January 13, 2004

In his December 11 letter to Mr. Richard Powers of my staff, your consultant Mr. James Albritton, requested Federal Highway Administration acceptance of specific design changes made to the original TRACC crash cushion. These changes were:

Figure 1. Details of sled assembly.

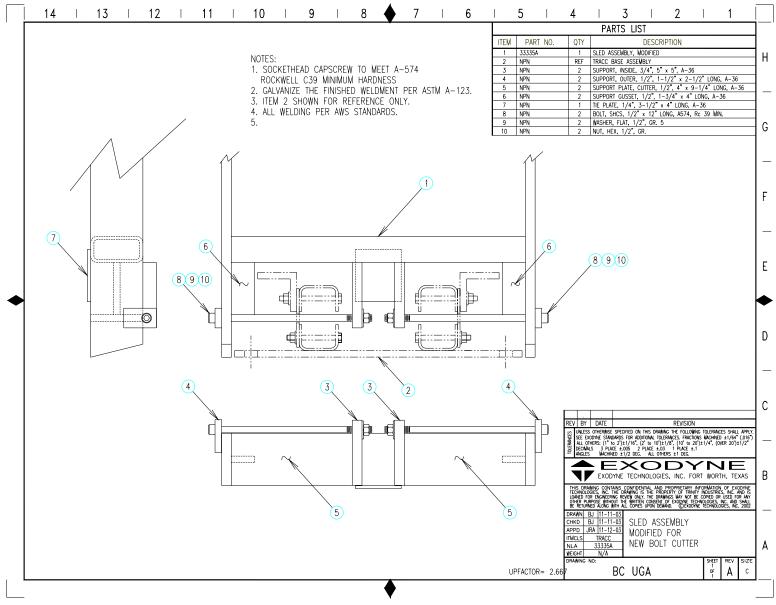
- The impact sled was changed from a single weldment to a six-piece bolt-up assembly. As seen in enclosure 1, the weight of the sled was reduced by eliminating the original four horizontal angle stiffeners and bolting the w-beam side panels directly to the impact sled frame using high-strength 5/8-inch bolts, with a 1/4-inch rectangular washer (2-1/4 x 3) under the head of each bolt on the outside of the panels and two rectangular washers between each panel and the frame acting as spacers. This connection will be part of the TRACC assembly done by Trinity prior to shipment.

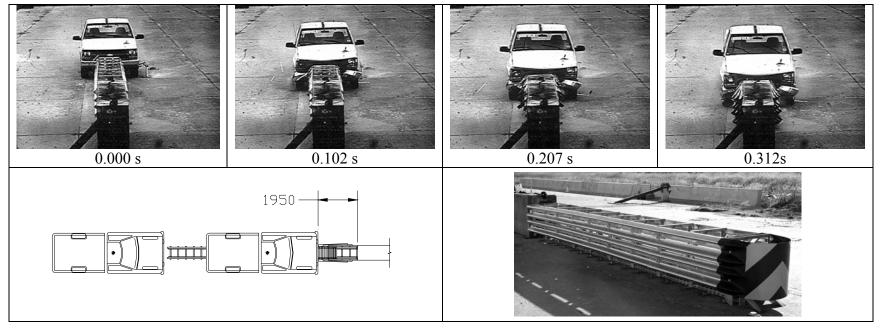
- The original single-piece, heat-treated cutter plate in the impact sled was replaced with a pair of hardened steel bolts, backed by a steel plate welded to the sled assembly (enclosure 2). The leading edge of these bolts shear the rip plates when the front end of the TRACC is impacted and the sled is forced backwards.
